**TECHNICAL EVALUATION REPORT
CHRISTENSEN RANCH MINE UNITS 2 THROUGH 6 RESTORATION REPORT
URANIUM ONE USA, INC., WILLOW CREEK ISR FACILITY**

DATE: October 23, 2012

DOCKET NO.: 040-08502

SITE: Willow Creek Christensen Ranch, Wyoming

Figure 3c. MU2 North and South Radium-226 Stability Monitoring Trend Analysis

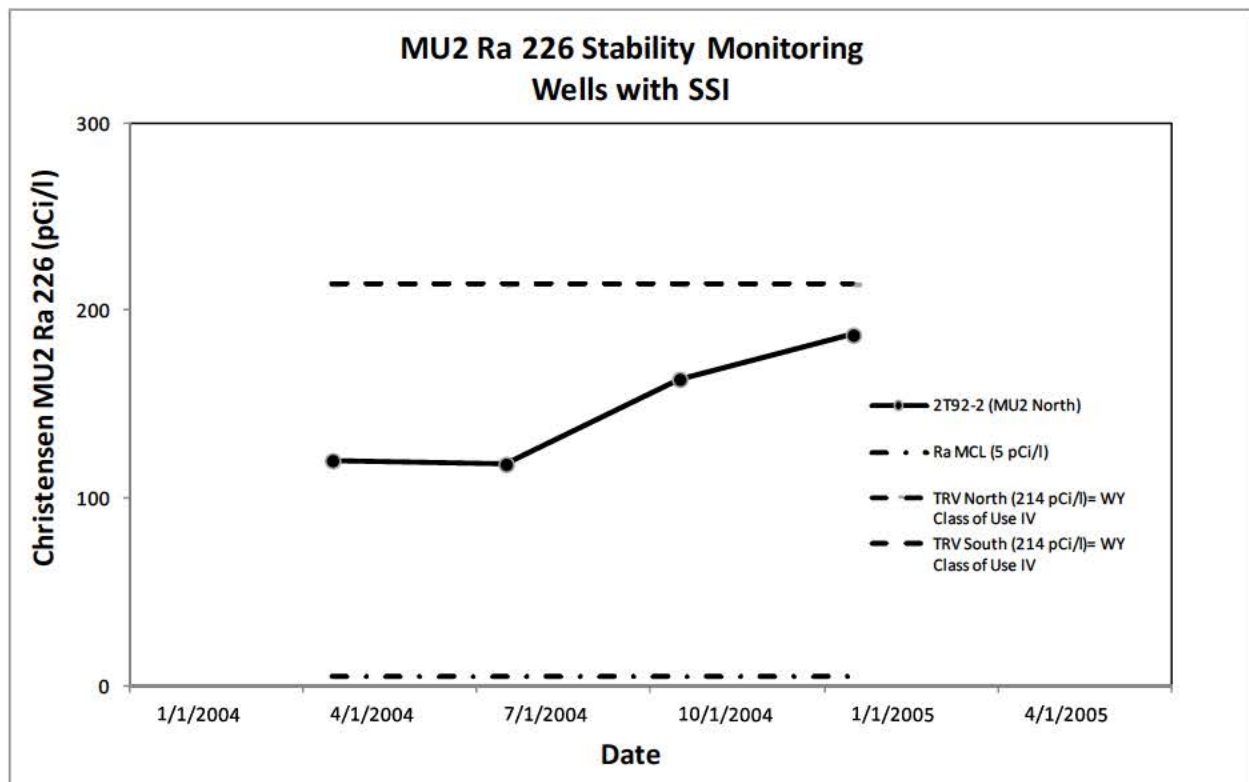
The SSI trend for Mine Unit 2 South for uranium in this well is shown in Figure 3c. It is of concern to the staff because it shows that uranium in this well is above the Class IV standard (background TRV) and is increasing.

- (1) Demonstrate that the SSI trends for uranium and radium-226 at well 2T92-2 are reversed and stable.
- (2) Provide a confirmatory analysis of the groundwater quality at well 2MW108 subsequent to the corrective actions for the 2011 excursion that demonstrates impacts to the aquifer following the 2011 excursion event meet regulatory requirements (groundwater protection criteria).
